**Re: Fremont Apartment Project Design Revisions**

# fremont place

2018-04-11  
proposed design revisions

12 **appendix:**  
greenway section comparison

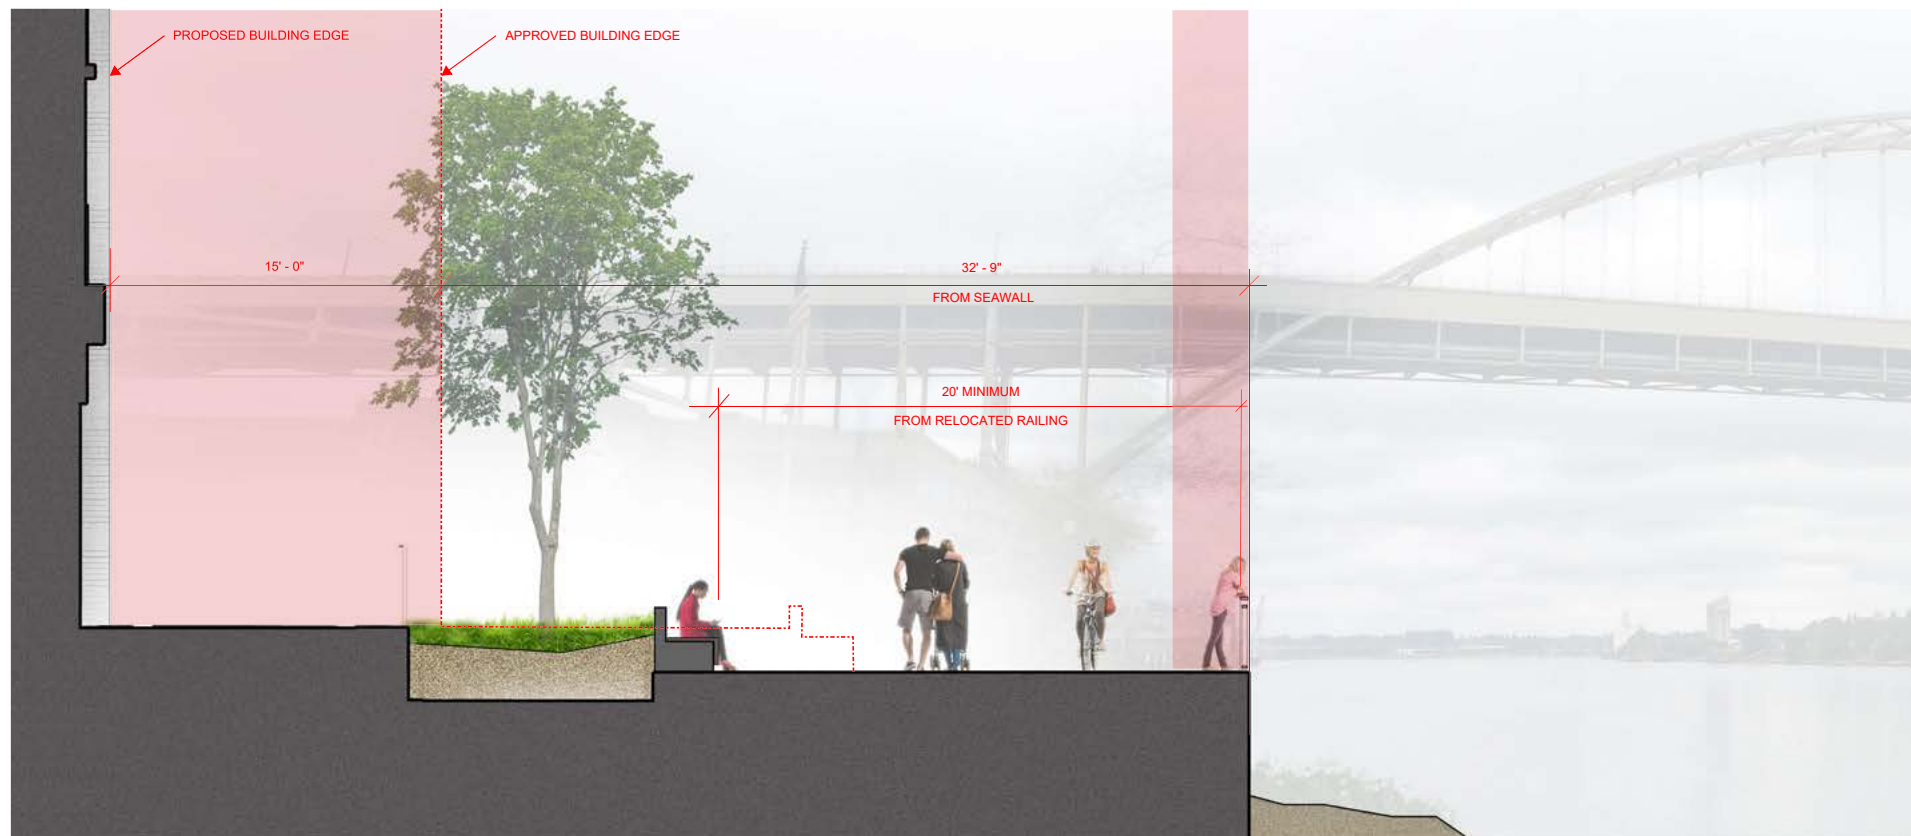
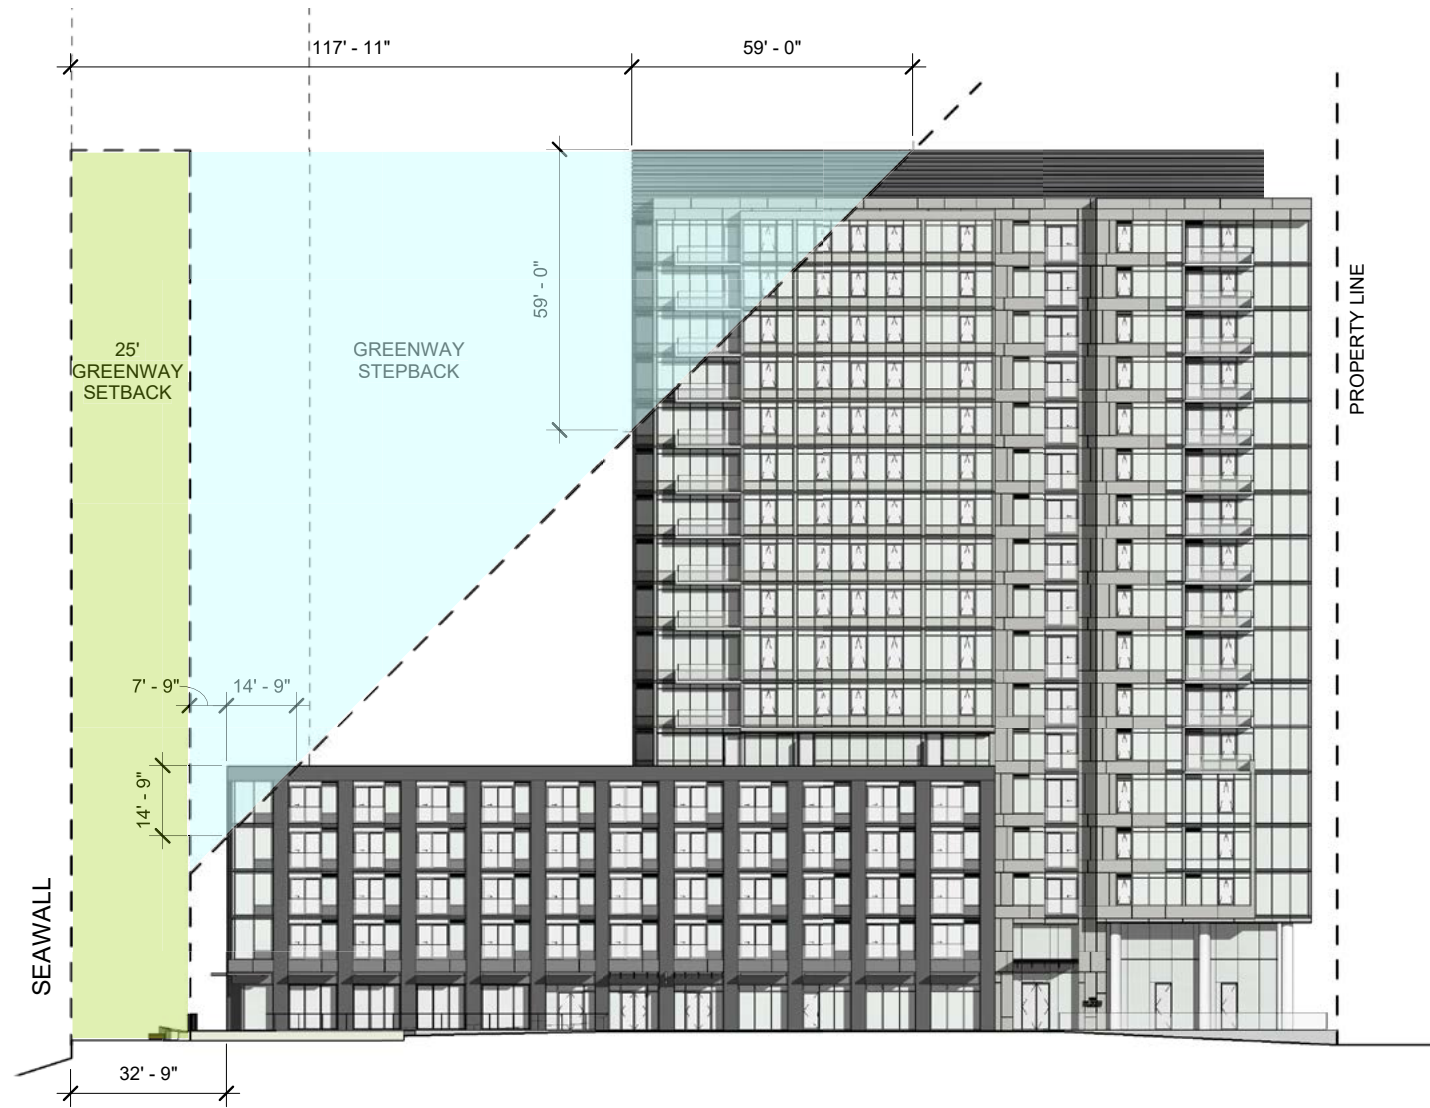
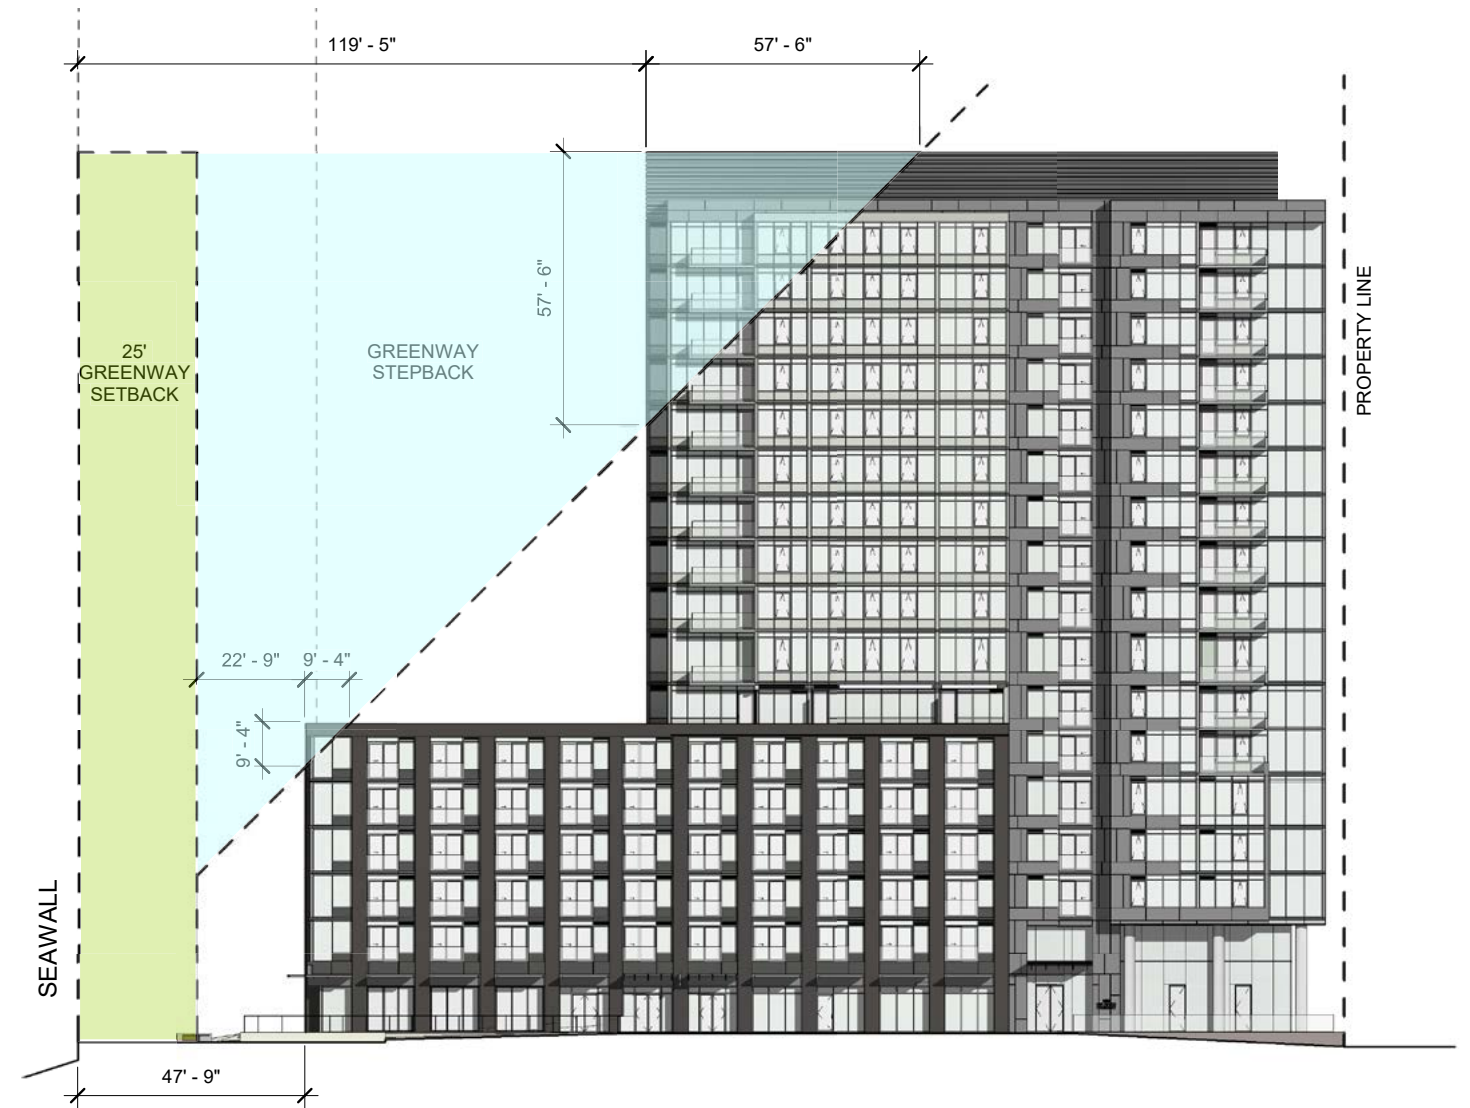
previously approved design (section view):

proposed design revisions  
(section view)

# dimension: building maximum length between greenway & naito

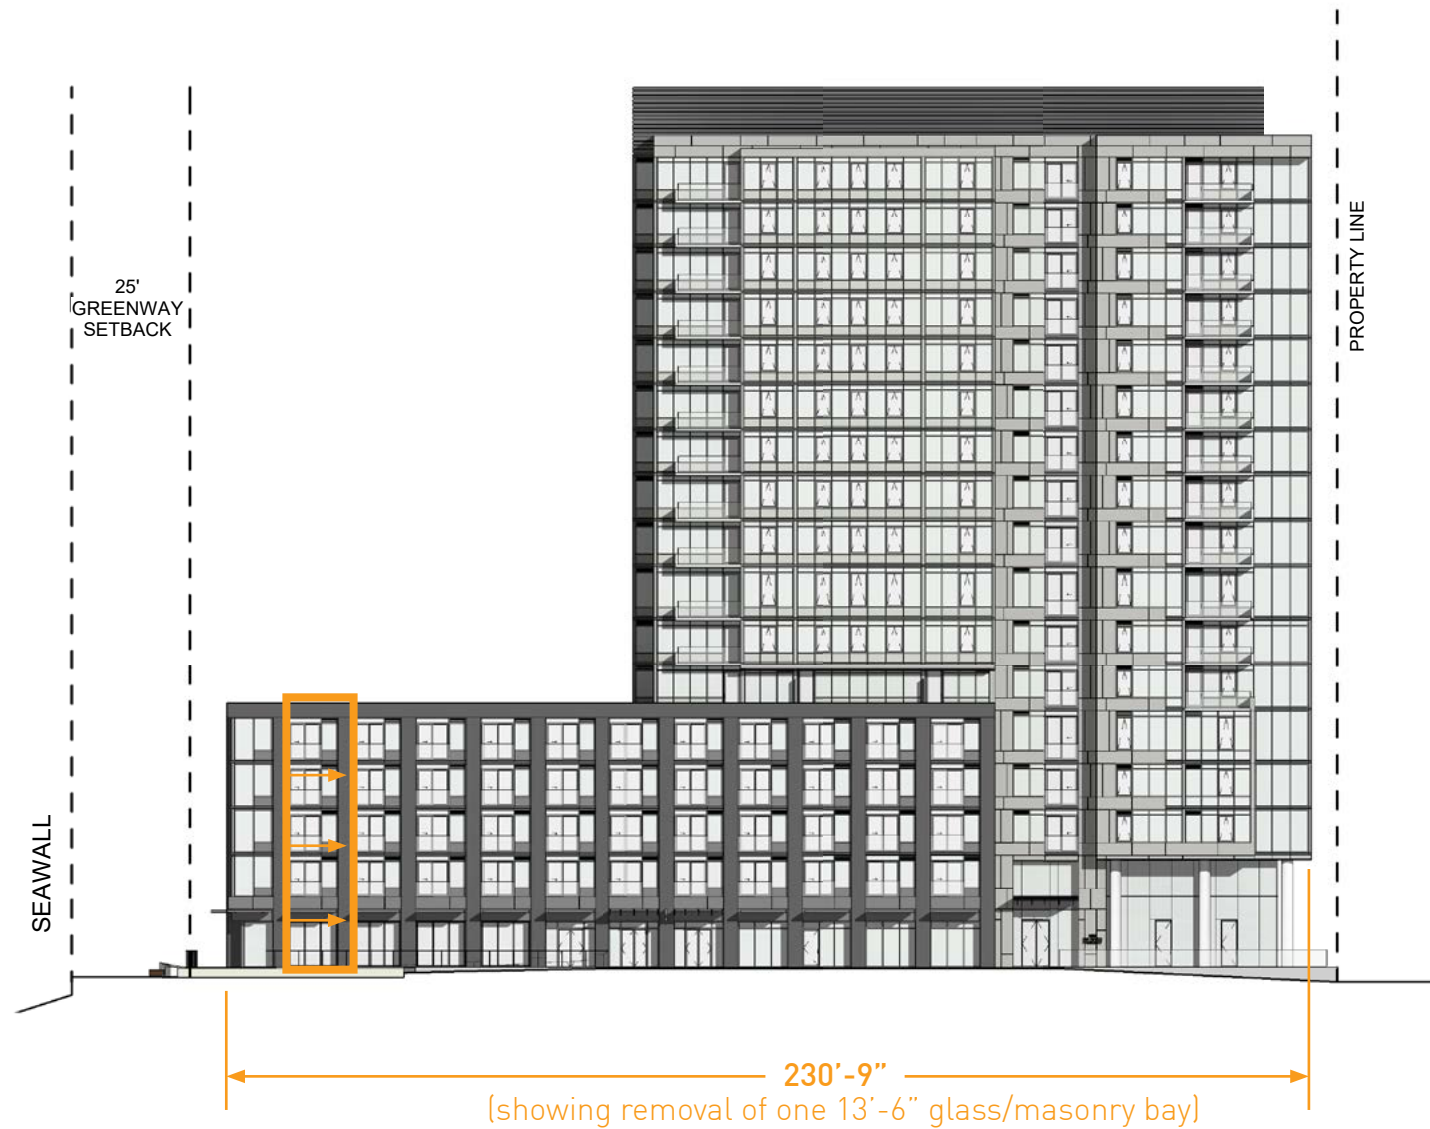
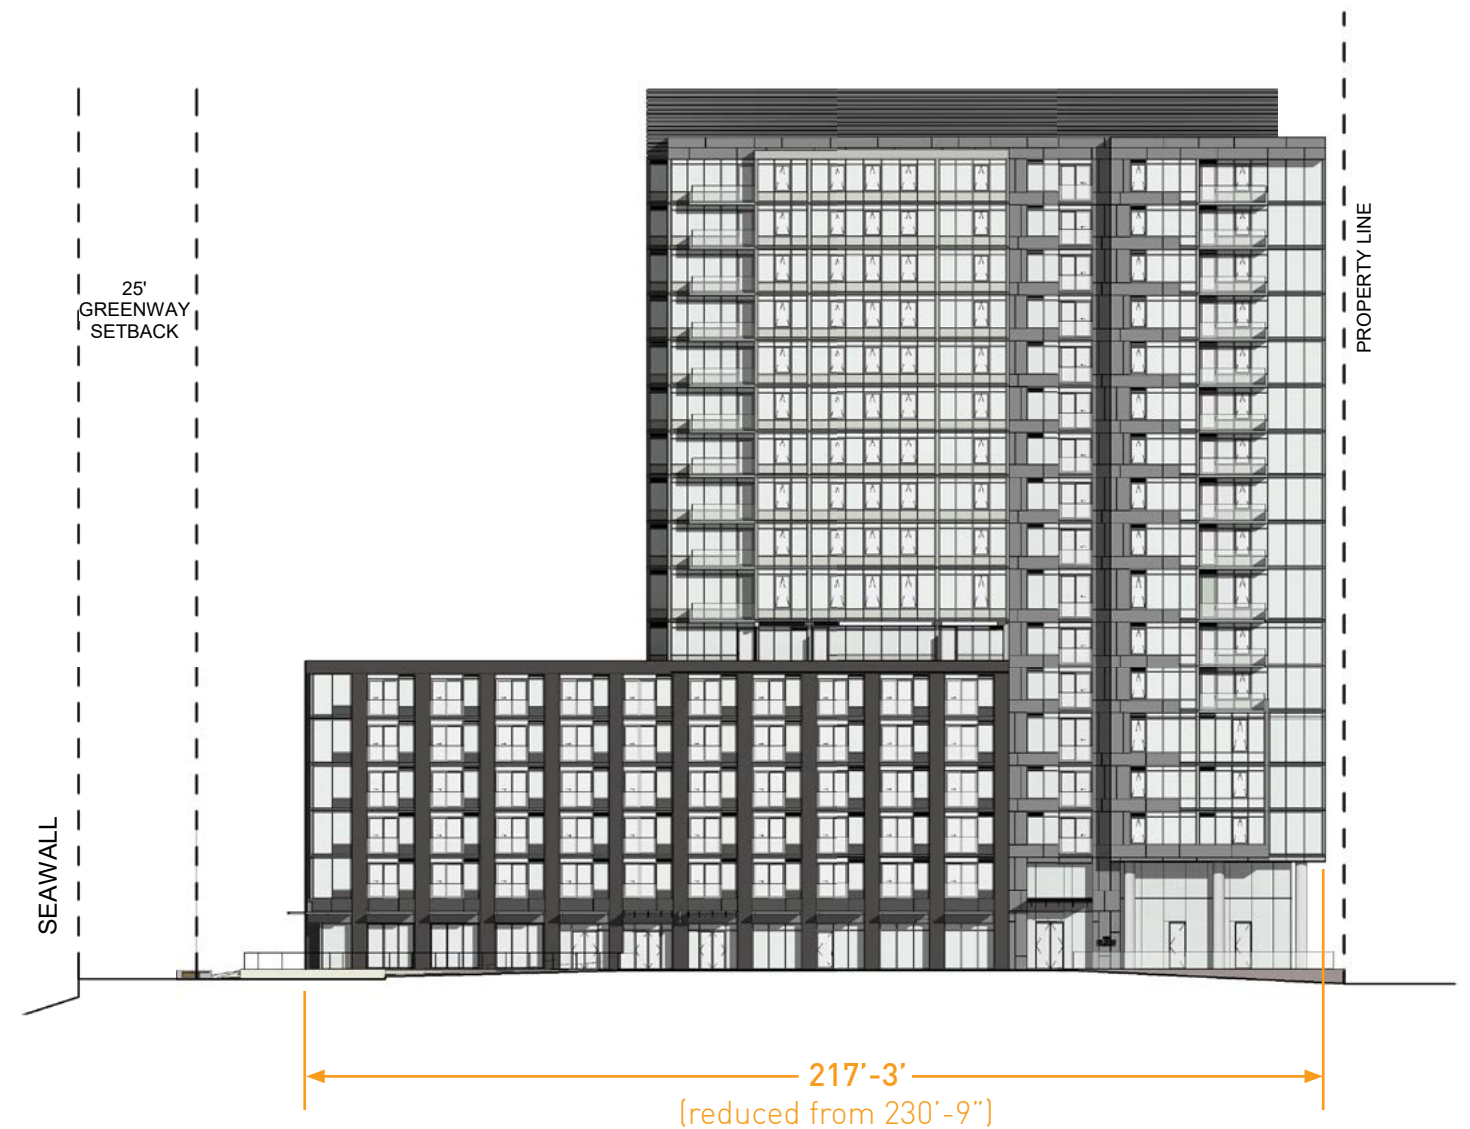
previously approved design (north elevation)

proposed design revisions (north elevation)
